Certificate of Appropriateness

BAR 21-11-03

122 Maywood Lane, Tax Parcel 110060000

**CITY OF CHARLOTTESVILLE
BOARD OF ARCHITECTURAL REVIEW
STAFF REPORT
November 16, 2021**

122 MAYWOOD LANE
CERT. OF APPROPRIATENESS
APPLICATION PACKAGE
PROPOSED ELEVATIONS

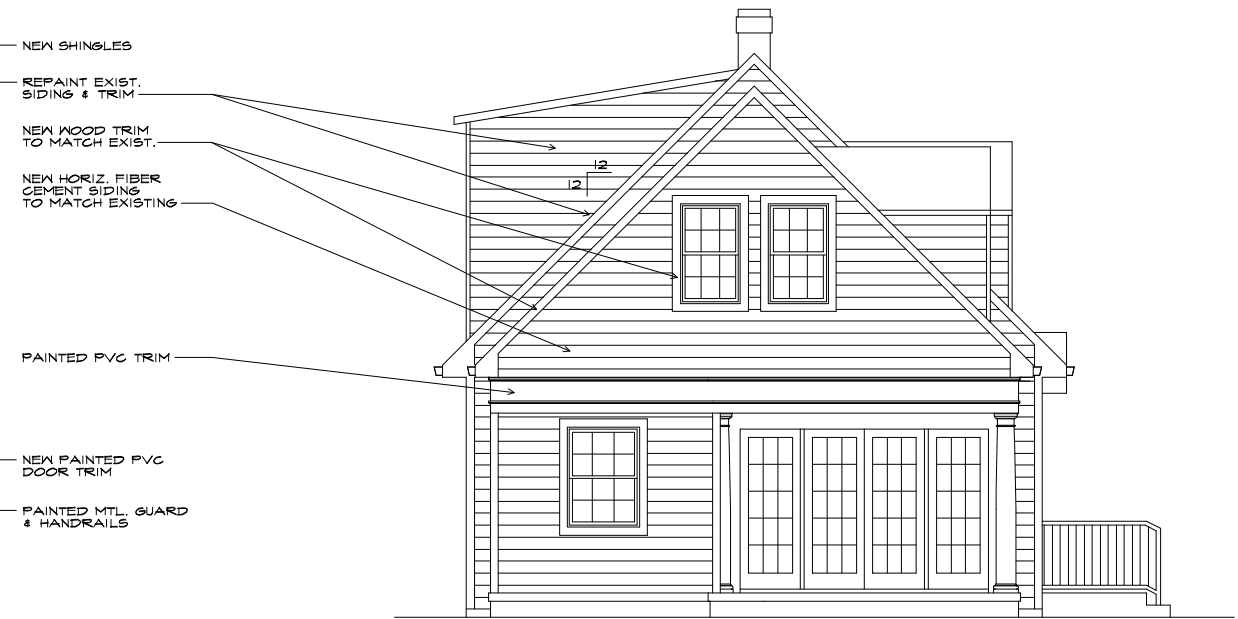
Mohr: Generally, I don't have a problem with the proposal, other than that front stoop and the little hood, which seems to be a real part of the character of the house.

Balut: I agree with Tim's comment that it is unfortunate to lose one of the key identifying features of the house. What you have proposed with it extruding out, is perfectly within our regulations. Is the size of that pediment larger than what currently exists?

Mohr: I think it makes more sense to take that existing hood and extend it. The scale of it seems right for the building, and the one you are proposing looks a little bit too fancy, for lack of a better word. If you extend it to 3 or 3 ½ feet out, then you get the coverage while you are under the door.

Mohr: You wouldn't include the columns. You could just have it cantilevered. It would be little tricky, but it is possible. My concern is that little hood seems like a character defining feature of the house.

Sarafin: The hood with the dormers makes the composition of the house. I would be inclined to not alter the entrance; I think everything else is entirely appropriate.

Sarafin: I would argue that the porch with the slight cantilevered overhang as it exists is a character defining feature of this style colonial style house that I would argue ought to be retained. It is such a character defining feature of this style and time period of house and I would hate to lose it.

Schwarz: I am curious on what you are planning for the overhang of this door.

Having considered the standards set forth within the City Code, including City's ADC District Design Guidelines, I move to find that the proposed alterations at 122 Maywood Lane satisfy the BAR's criteria and are compatible with this property and other properties in the Oakhurst Gildersleeve ADC District, and that the BAR approves the application as submitted, with the following conditions:

- Cut sheets for the windows and doors will be provided [to staff] for the BAR record.*
- The insulated glass will have internal spacer bars that align with simulated divided lites*
